A. Pre 1984 Merc 18 & 25 Lower Units Below The Following Serial Numbers:

B. 1984 Merc 18XD & 25XD Electric (E& EL) Models

CIRCULATE TO:
SERVICE MANAGER
PARTS MANAGER
MECHANICS
"Place in a Service
Bulletin Binder"

Gear Housing With .234" (5.94mm) Thick Thrust Washer (96524) Above Pinion Gear

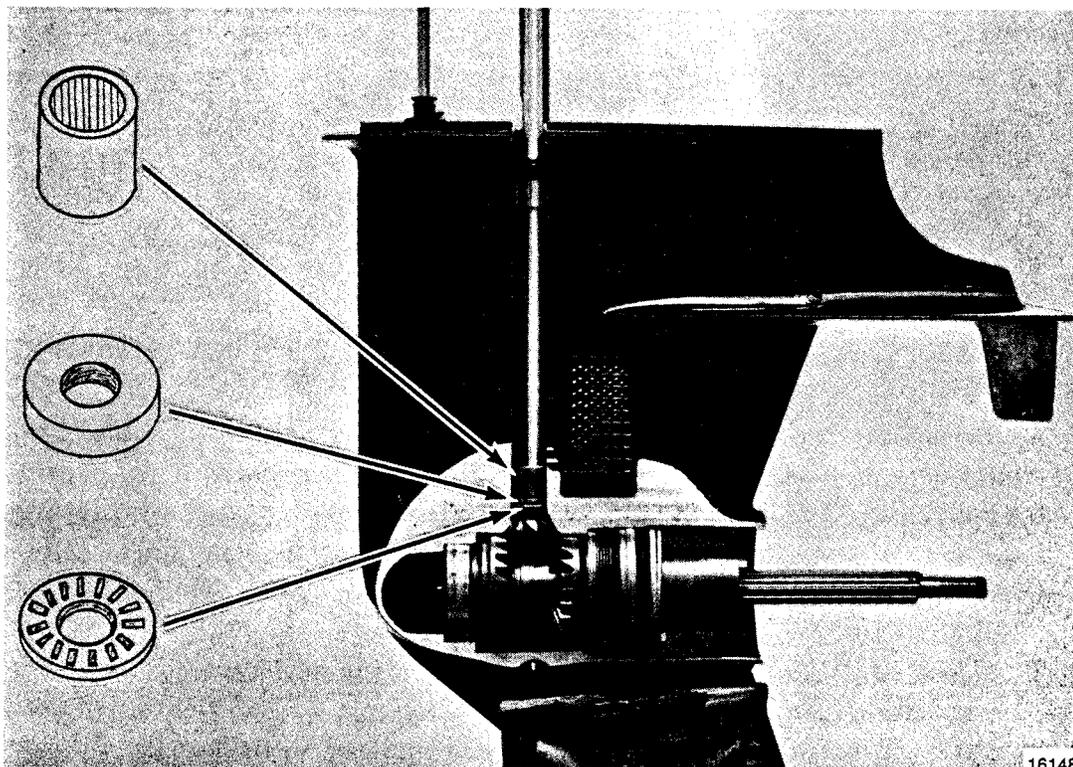
As indicated in the Parts Lists, Merc 18 and 25 lower units (within the above serial number group) were built with either a .080" thick thrust washer or a .234" thick thrust washer above the pinion gear. The .234" thick thrust washer was then superseded with bushing 98861A1. Due to an oversight, the bushing was not listed in the parts lists. They will be corrected. To clarify:

DO NOT install this bushing in a gear housing that is equipped with .080" (2.03mm) thick thrust washer (12-94056) above pinion gear or gear housing damage may result.

IMPORTANT: This bushing replaces .234" (5.94mm) thick Thrust Washer (96524), lower Driveshaft Bearing (31-85559), and Thrust Bearing (31-85560) in Merc 18 and 25 HP gear housing assemblies equipped with .234" (5.94mm) thick thrust washer.

1. If a replacement bushing is required, order 98861A1 to receive the bushing and installation instructions.
2. When .234" thick thrust washer is ordered, it will be superseded by bushing 98861A1 and installation instructions.
3. DO NOT install bushing in a gear housing equipped with .080" thick thrust washer or gear damage will occur.

1. Refer to Step 1 for component removal.
2. Refer to Step 2 for bushing installation.

Remove and discard thrust bearing, thrust washer, and lower driveshaft bearing.

Figure 1.

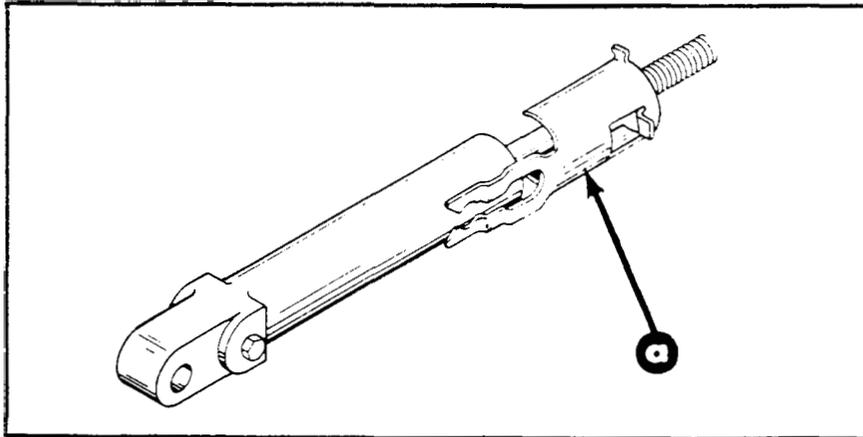
Some competitive remote control cables cannot be used on the 1984 electric models.

The reason is that quick connect cable retainers were specifically designed to fit the round cable guides used on Quicksilver remote control cables. (Figure 1)

Some competitive remote control cables have cable guides with different contours and the quick connect cable retainers cannot be easily adapted. This is another reason to use only genuine Quicksilver parts and accessories.
